ARBORICULTURAL ASSESSMENT – BUILDING A

S75W Proposal for Approved Development:

Stage 1 Works, 120-128 Herring Road, Macquarie Park, NSW

10 August, 2012

Figure 1 (above)
Shows the SRZ's (inner, red dashed circles) of T26 and T27 and the location of the approved planter wall. The TPZ of T26 is also shown (outer, blue dotted circle).
Drawing not to scale.

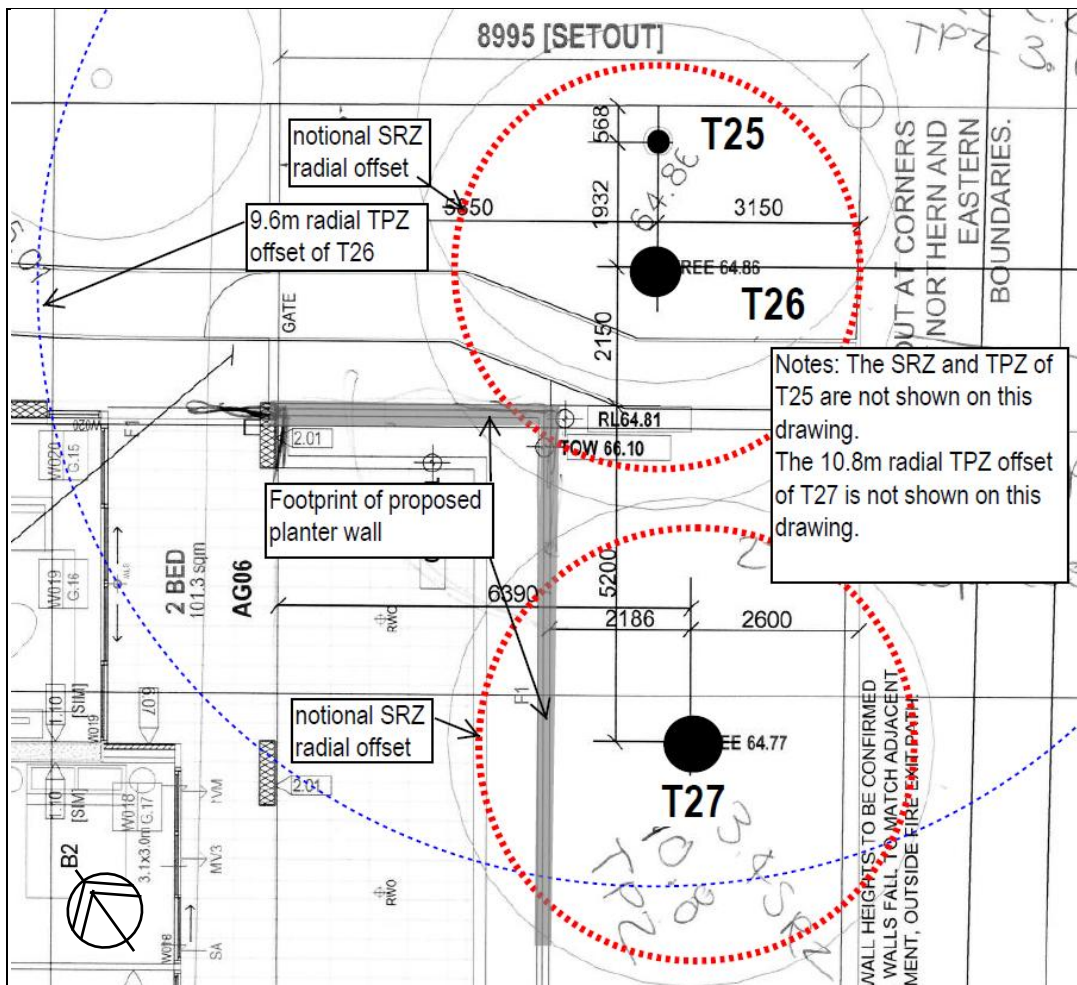
This tree has a DBH of 800mm. Its SRZ is a radial offset of 3.2m. Works identified in the SRZ are a strip footing for a planter at the east side of the building and a pedestrian path providing access to Herring Road (Figure 1, page 7).

15. Despite the very small portion of the notional SRZ that projects into the planter wall footprint, it is possible *woody roots*⁵ are present and would be severed or damaged for the wall construction. Given the base RL of the wall is similar to the RL of the tree, there is scope to retain significant roots by bridging them with a lintel supported on the footings. An arboriculturist will need to supervise this work to ensure anchor roots are not damaged during initial investigation to locate important roots and the subsequent method of footing construction used to avoid damage to those roots.

16. The proposed path is well inside the SRZ. It is most likely this path will need to be constructed to avoid any excavation into the root zone. The existing ground is relatively level in the tree's vicinity, so it appears the path could be installed to sit on top of the ground, with very minor depth of fill to camber up to the path edge. Even if the path is of an impermeable surface, if installed on the existing ground the impact will be minor, avoid cutting of woody roots and allow generation of smaller roots beneath it.

19. Tree 27 – *Cupressus macrocarpa* (Monterey Cypress)
This tree has a DBH of 900mm. Its SRZ is a radial offset of 3.4m. Works identified in the SRZ are a strip footing for a planter at the east side of the building (Figure 1, page 7).

20. The proposed footing extends more than 1m into the tree's SRZ, and for a distance of 5m or so across the SRZ. There is a distinct possibility that woody anchor roots would be present in the SRZ area projecting into the planter wall footprint.

21. As discussed for Tree 26, there appears to be scope to utilise bridged footing construction to avoid the significant anchor roots, however, UFA has estimated the TPZ encroachment is approximately 137m², or around 37% of the total TPZ area. This is a significant encroachment and, due to the proportion of *non-woody roots*⁶ likely to be removed, subsequent decline and removal of the tree is likely.

37. Tree 26 (Scribbly Gum) – Retain and protect.
- Path construction above the existing ground level (no excavation for path within the SRZ).
 - Prior to construction the project arboriculturist is to investigate the location of significant roots potentially affected by planter wall construction (e.g. root mapping, via hand digging or Air-spade®).

- Planter wall construction is to adopt appropriate methods to avoid cutting of any roots identified to be retained by the arboriculturist.
38. Tree 27 (Monterey Cypress) – Remove, due to unacceptable impacts on TPZ, crown structure and tree form.

Figure 2 (left)
Shows the SRZ (red dashed circle) of T28, proximity of the excavation for the proposed amended OSD tank location and area of SRZ encroachment.
Drawing not to scale.

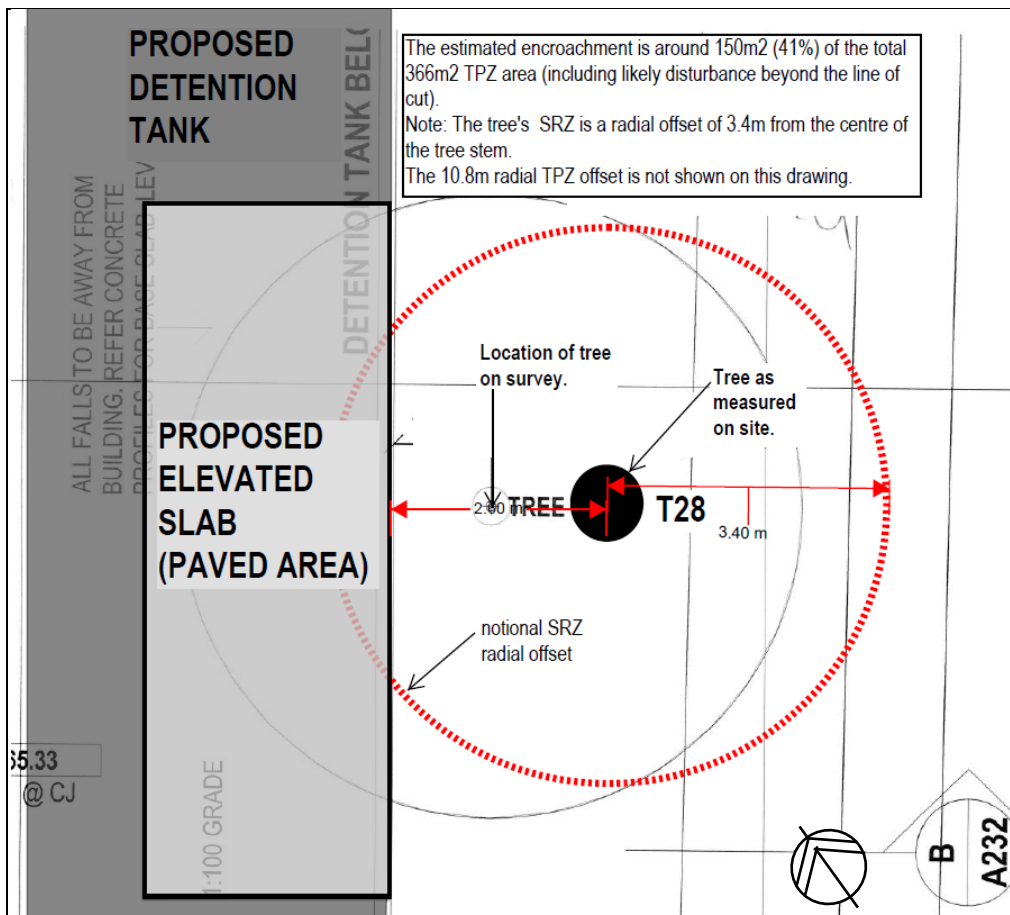
25. Figure 2, page 7 illustrates the amended footprint of the approved OSD (as per arboricultural advice) to avoid bulk excavation within the tree's notional SRZ. The proposed elevated paving slab is, in theory, the only SRZ encroachment, although the slab could be constructed to avoid any conflict with woody roots encountered at construction stage. UFA notes an existing low concrete wall at the base of the tree on its east side has likely constrained woody root growth in this east direction to some degree. Subsequently, significant anchoring roots are likely to extend further west than the notional 3.4m offset and be well within the footprint of the proposed elevated slab and possibly within the proposed excavation for the OSD.

26. The TPZ of this tree is a 10.8m offset comprising a total 366m² protection area. UFA has calculated the proposed TPZ encroachment (including disturbance beyond the excavation footprint) to be in the vicinity of 41%, which is significant and could lead to irreversible decline in tree vigour and viability.

27. To retain a tree of this size, age and low tolerance to development impacts would require major design changes that separate excavation and any structures including footings from the tree by a minimum distance of 7m to decrease the encroachment to a more tolerable range of 15% – 18% of the entire TPZ area.

39. Tree 28 (Scribbly Gum) – An AQF Level 5 arboriculturist is to supervise the OSD and elevated concrete slab works undertaken within 8m radius of the tree, and provide advice in regard to any other works (e.g. landscape hardworks, ground level changes, etc) that may have potential to harm the tree.

- Specific tree protection devices are to be installed under the advice of an AQF5 arboriculturist.
 - Possible irrigation requirements under the elevated slab is to be investigated by the AQF 5 arboriculturist

Plate 1 Looking NE to Tree 27, illustrating the estimated removal of crown to accommodate the unit terraces and pedestrian clearance beneath the tree (red shaded area). The projected removal is likely to be much greater if construction scaffolding is erected (yellow area).

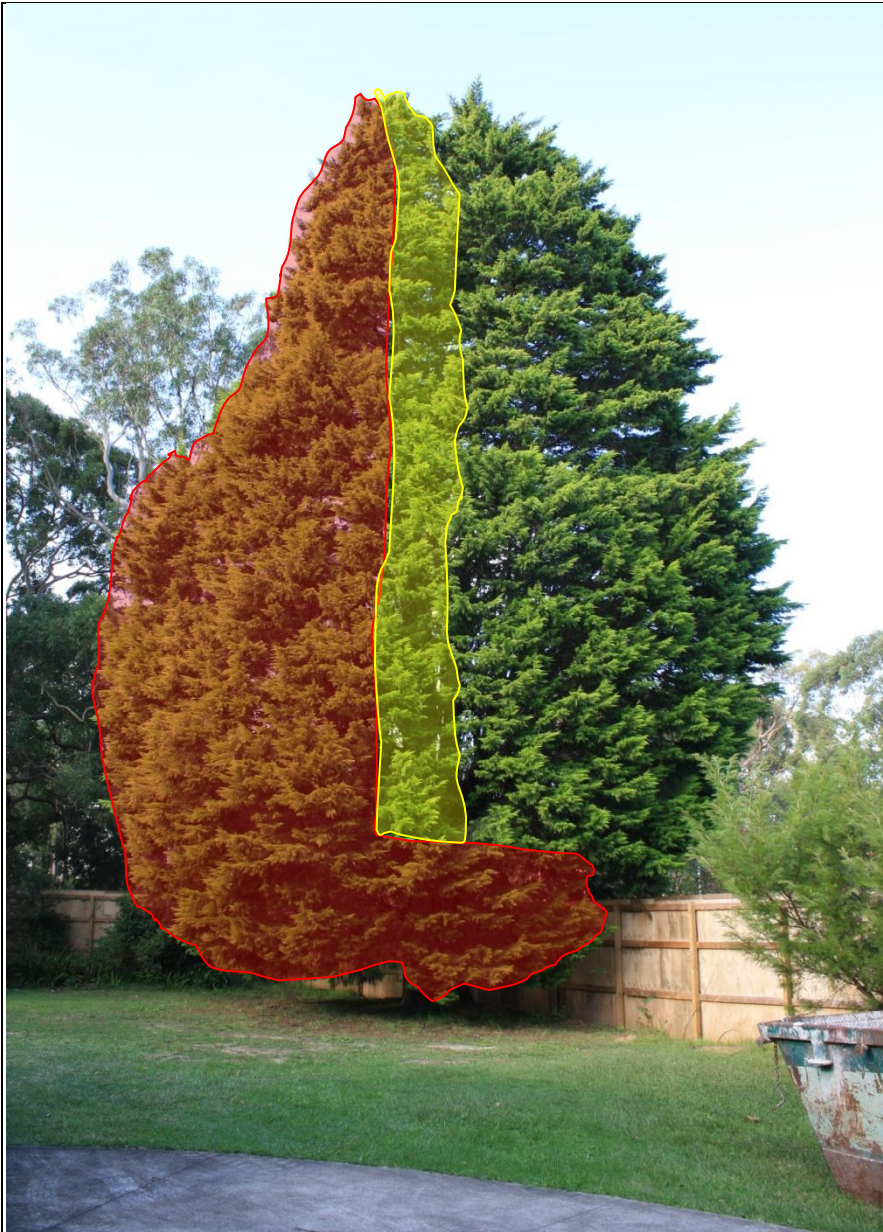
22. The tree will also require excessive pruning to lift the crown of the tree on its north, west and south sides to enable pedestrian access around the building and to clear the terraces of units facing the east. The terraces are approximately 2.2m from the centre of the tree. Construction scaffolding will reduce this setback to the tree to a point almost directly over the main stem. See Plate 1, page 8 for a schematic estimate of crown loss from pruning.

23. Pruning of the tree will potentially remove up to 60% of the current foliage, expose the bare, 'internal' frame of the tree, which is highly unlikely to generate new growth, and drastically affect the natural form of the tree.
